Wessex Water Services Ltd Response to Ofwat's PR19 Draft Determination – August 2019

Representation reference: Cost Assessment C5

Representation title: WINEP: Flow to full treatment (FFT) increase

Figure 1: Total and average increase in FFT for different WaSCs

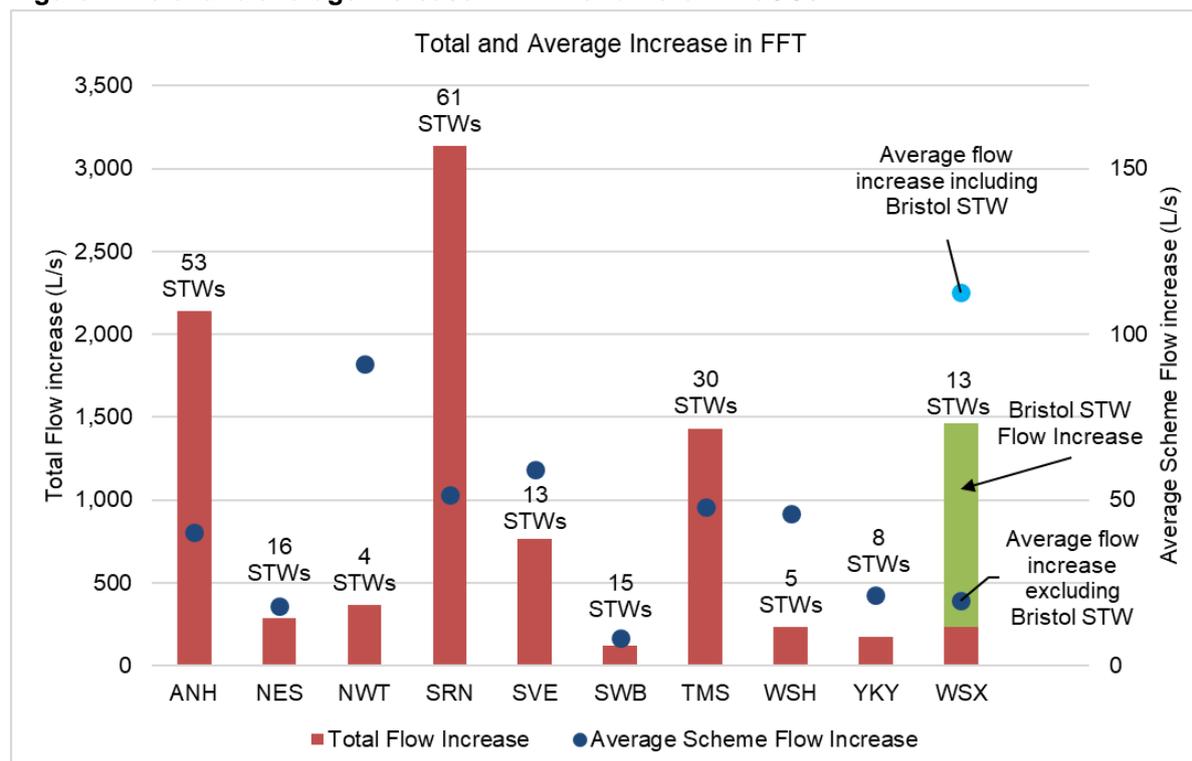
Ofwat's feeder model uses "Number of schemes in business plan" and "Shortfall in FFT (l/s)" as the two parameters driving the model. This is shown graphically in the figure below.

Our review of the cost assessment model indicates that there are limitations within the model which are due to the amount of flow increase at Bristol and Bath STWs when compared to other STWs within the model. Using Ofwat's cost assessment enhancement feeder model results in a totex funding implied allowance of £22.402m for Bristol STW against our business plan totex cost of £43.842m, a reduction of some 49%, and an implied allowance of £10.362m for Bath STW against our business plan totex of £22.322m. We consider that these do not allow sufficient funding to deliver either scheme of this size and complexity, as demonstrated by evidence in our previous submissions and confirmed by independent assessments of both the technical scope and estimated costs.

Annex A. Proposed layout at Salford (Bath) STW to meet WINEP requirements (Extract from Response to IAP, Appendix 4)

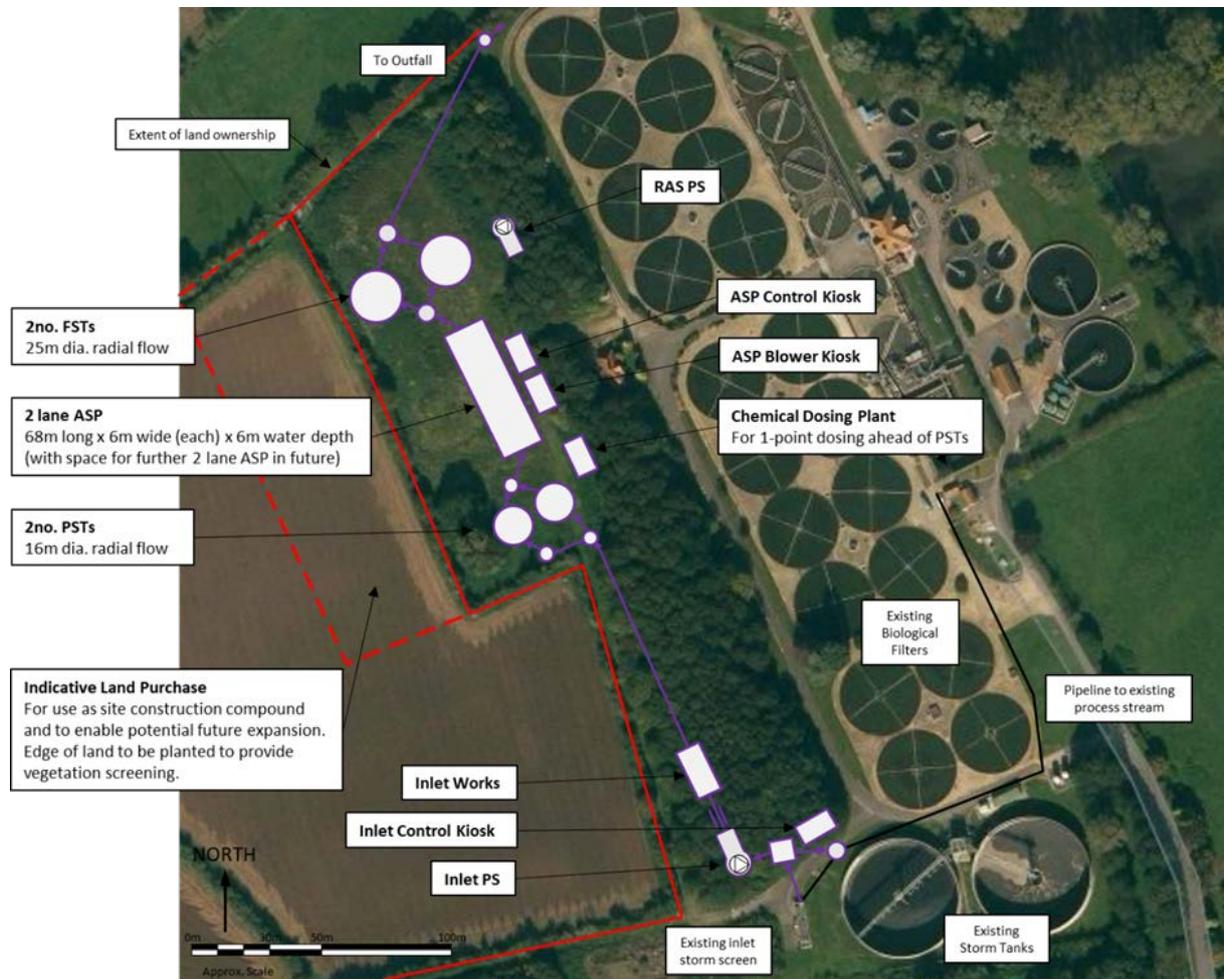
There are particular difficulties in constructing extensions at Bath STW. These are detailed within our IAP response and include access and site topography difficulties. Access to the site for large vehicles is very restricted, with public relations issues relating to the narrow access roads and residential housing in Salford village. We are planning to construct a new improved access to the STW, including a new bridge and access road over the river Avon to provide access for construction traffic in the short term and operational and maintenance traffic in the longer term. A proportion (~28%) of the total cost (£4m) of constructing the new access has been allocated to the FFT scheme, with the remaining 70% being funded from base capital maintenance. We believe this element of the works will be unique to our Bath (Salford) STW and hence not adequately represented in the cost assessment model.

As requested in our response to the IAP, we ask Ofwat to undertake a deep dive into the Bath (Salford) STW flow to full treatment scheme in order to fully understand its exceptional characteristics and scale compared to the remaining set of schemes included in their cost assessment model for FFT schemes.
